February 10, 2020

Questions from a Citizen and CMG responses:

Upper Septic System Area

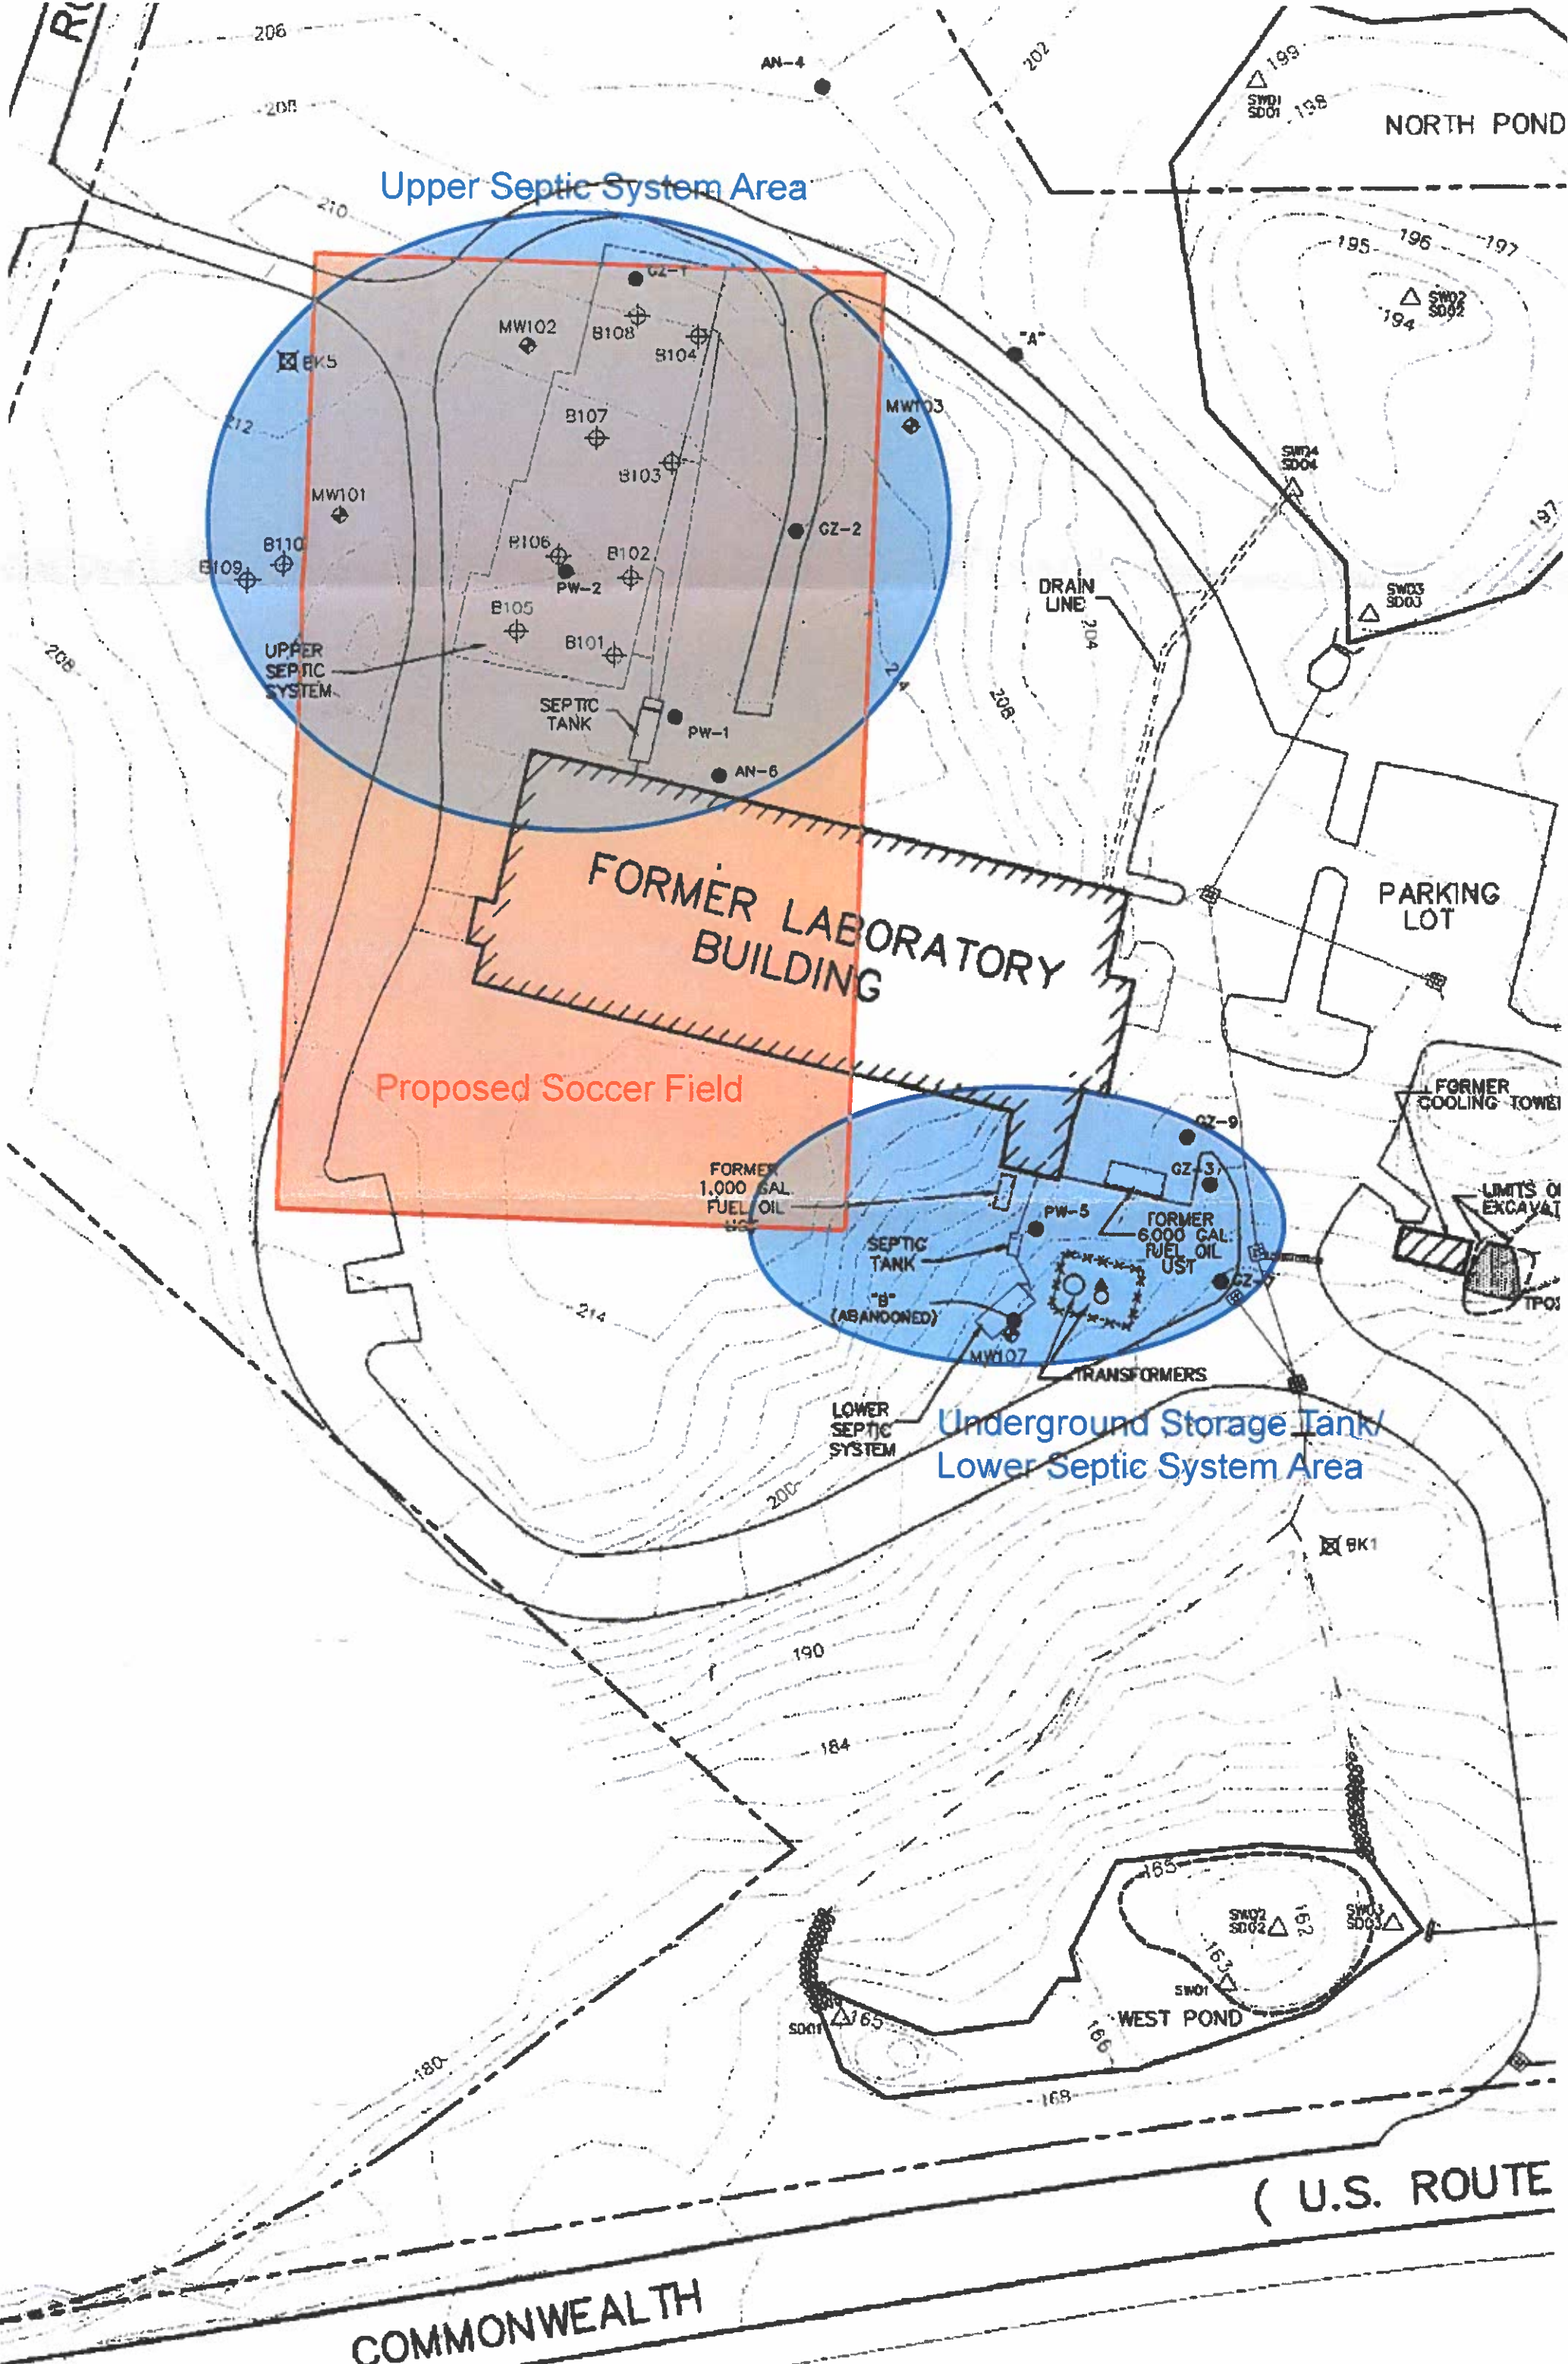
- 4) *Did he review the Weston and Sampson test results from samples they took from the bore holes used to determine the depth of the ledge. Was there enough sampling in the leach field area to assure that no hazardous wastes will emerge when the leach field is excavated.*

GZA advanced borings GZ-1 (refusal at 17') and GZ-2 (refusal at 8') within the footprint of the proposed soccer field. Anderson-Nichols also advanced boring AN-6 (refusal at 7') and Environmental Science advanced boring PW-2 (refusal at 9'3") within this footprint. 7/6/91

Ransom advanced borings B101 (8' no refusal), B102 (refusal at 6'9"), B103 (8' no refusal), B104 (7'6" no refusal), B105 (6' weathered rock), B106 (6' no refusal), B107 (6' no refusal), B108 (6' no refusal) B111/MW101 (competent rock at 20', well drilled to 29') & B112/MW102 (competent rock at 19', well drilled to 30') within the footprint of the proposed soccer field and B109 (4' no refusal) & B110 (2' no refusal) just west of it. They submitted 14 samples from borings B101 through B110 for laboratory analyses. This seems sufficient analysis to adequately characterize subsurface conditions within the "Upper Septic System Area."
